PLANNING BOARD MEETING

Trim Way Def. Subdivision- Response to Peer Review Comments

358 & 360 North Street Randolph, MA 02368

Trim Way

C-301 FIRE TRUCK TURNING PLAN

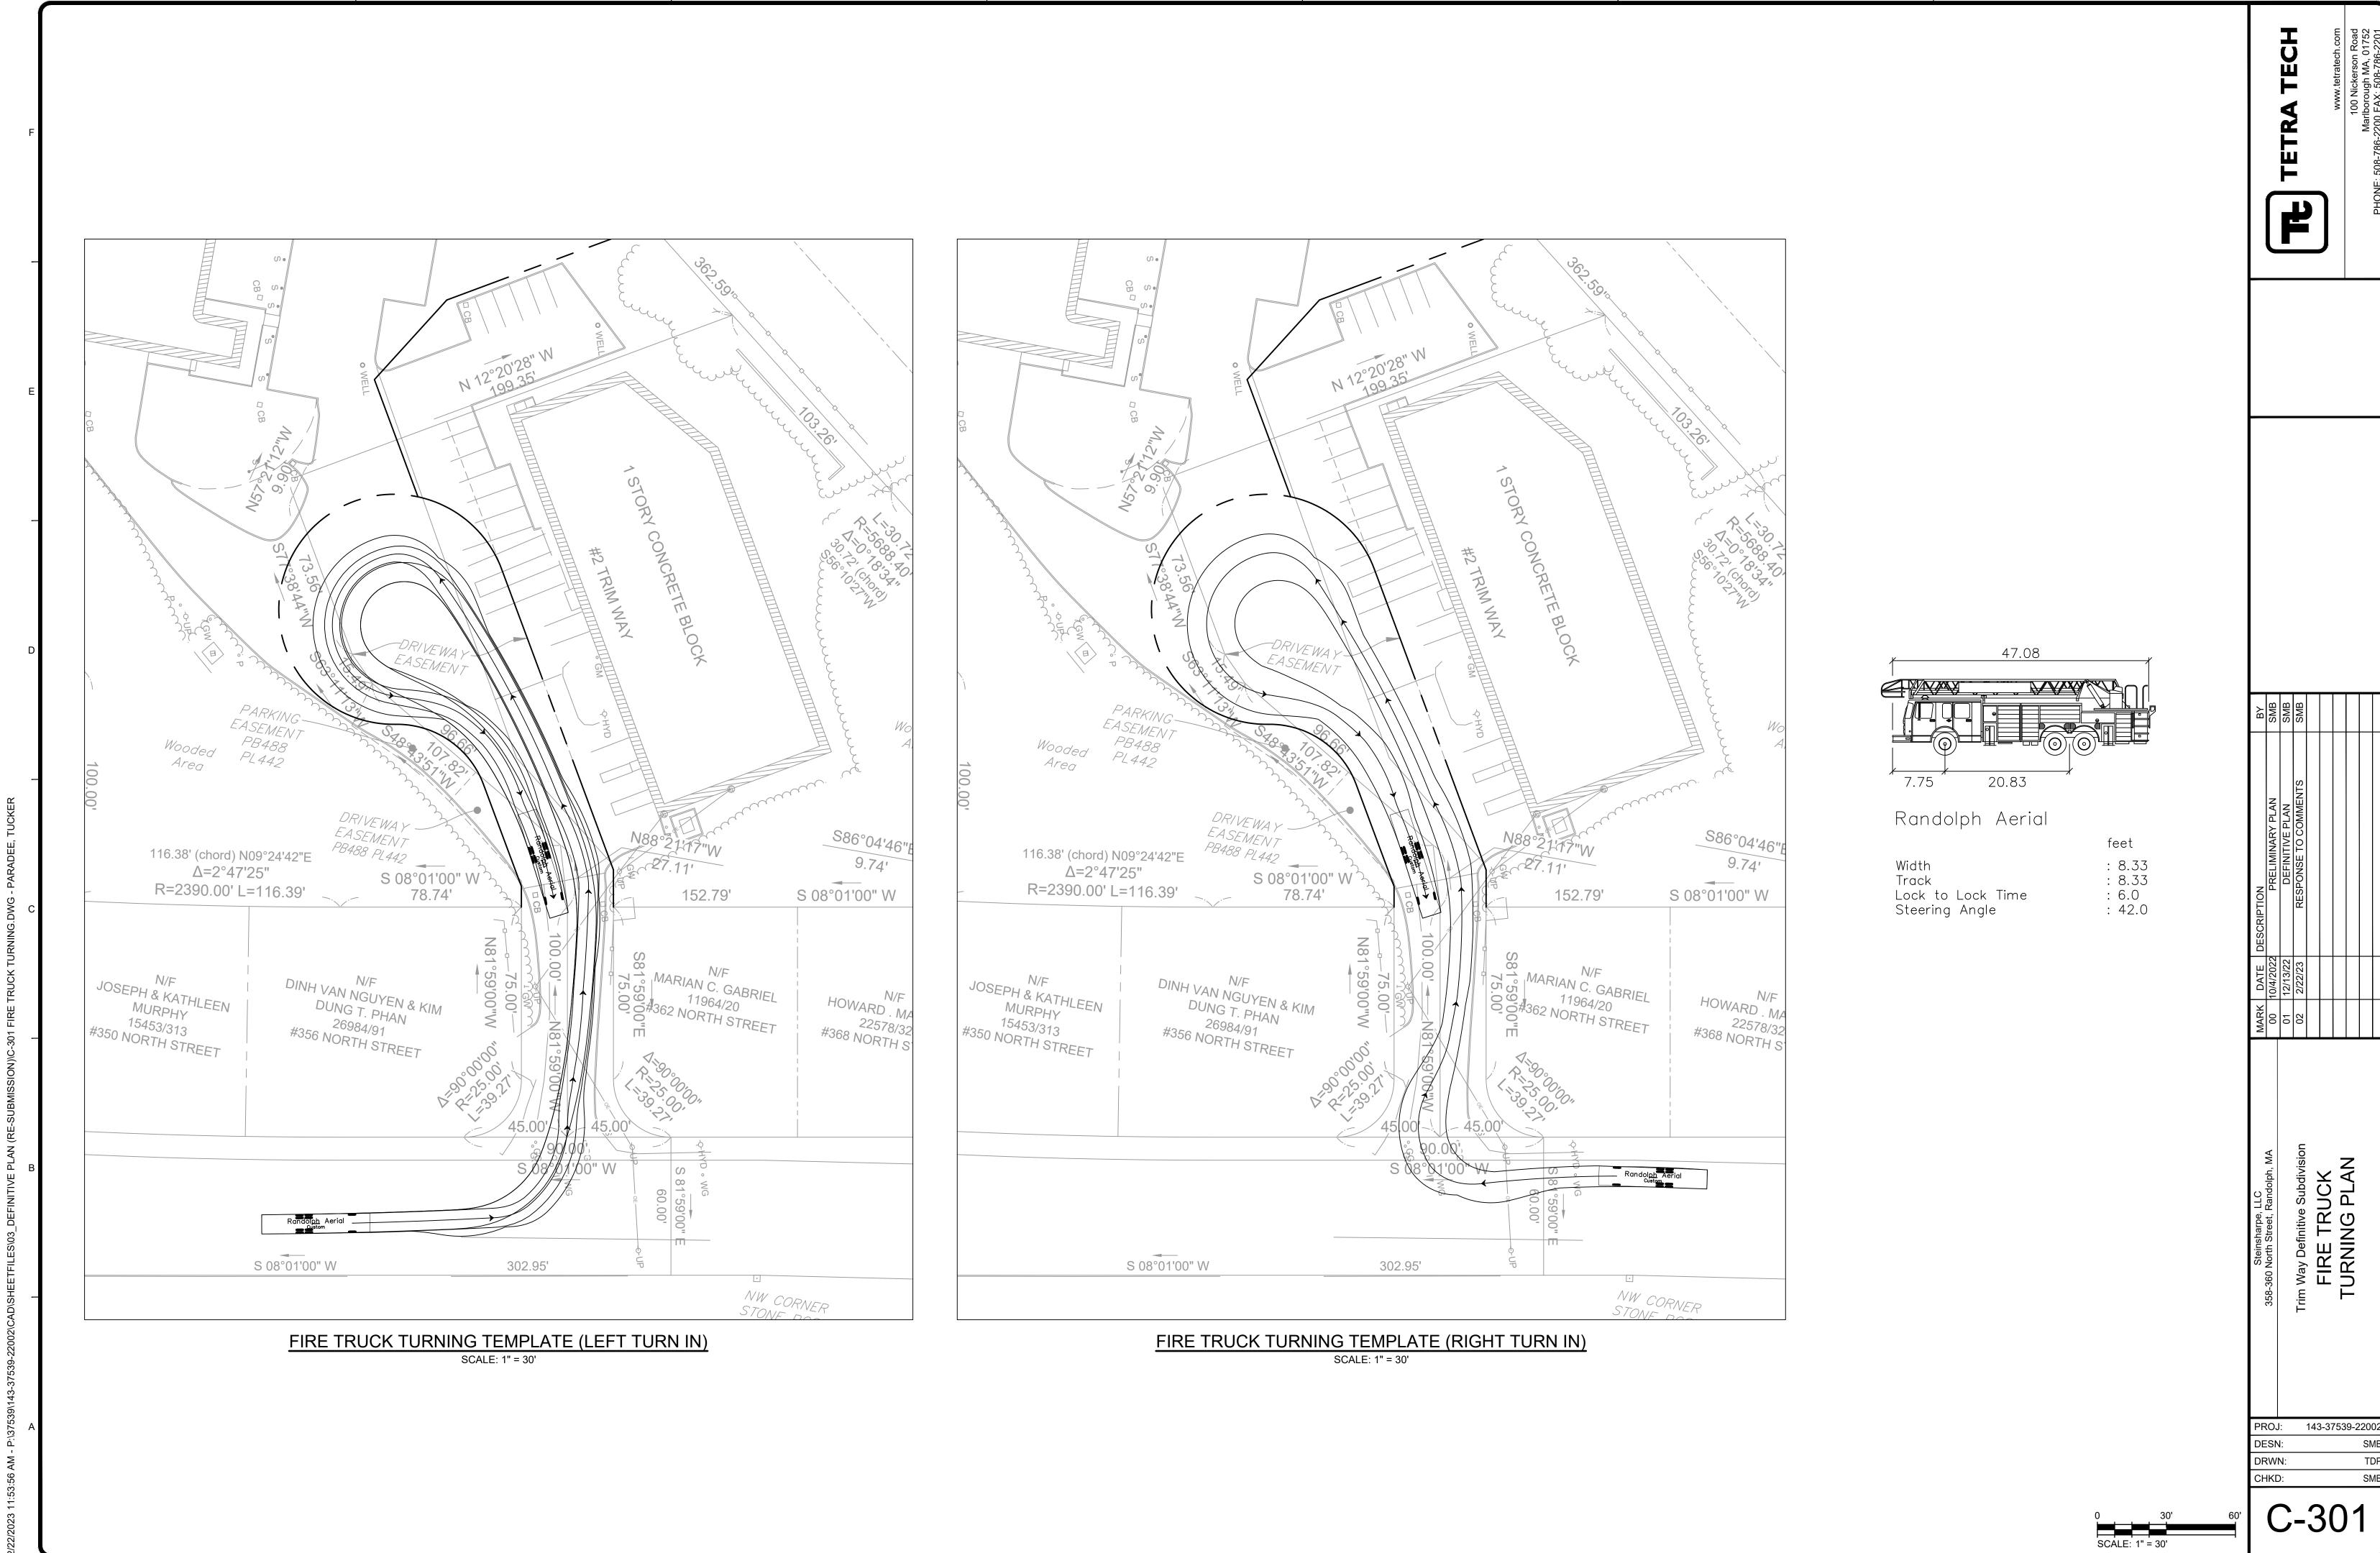
- 1. Several of the distances shown on the Lotting Plan differ from the record deed or plan for the parcel. See green highlighted distances on the attached plan.

- 2. A portion of the existing driveway easement is shown on the south side of Trim Way, but it is not labeled as such. There is also a parking easement adjacent to the driveway easement that is not shown at all. If these easements have not been extinguished, they should be shown on this plan.

- o TT/PLS 2/22/23 Response: They have been added and labeled on the updated Lotting Plan.
- 3. There appears to be two (2) property lines between #312 and #314 North Street. It is unclear if this is indicating a gap or overlap in the lots, but there is no indication in the record documents that this should be the case.

- 4. The Owner and Title reference are not given for #310 North Street.
 - o TT/PLS 2/22/23 Response: They have been added and labeled on the updated Lotting Plan.

- 5. The 50-foot easement line is not fully plotted.
 - o TT/PLS 2/22/23 Response: Item has been added and labeled on the updated Lotting Plan.
- 6. The lot for #304 North Street is comprised of two (2) lots under common ownership. The way the Lotting Plan shows the internal lot line makes it appear as though they are separate lots. A fee hook or some notation that the line is an internal lot line would clarify this.

- TT/PLS 2/22/23 Response: We have addressed the areas of differences. There was a difference in boundary line location as showcased on an AUL plan prepared by Hancock, supplied by the owner and attached to this letter. This plan and the monuments shown were used to help set the southern boundary. Other calculation differences have been called out as deed/plan.

- TT/PLS 2/22/23 Response: There appears to be a difference in the two abutters' deeds where neither deed is claiming this sliver. We have labeled this area as owner unknown.

- o TT/PLS 2/22/23 Response: They have been added and labeled on the plan.
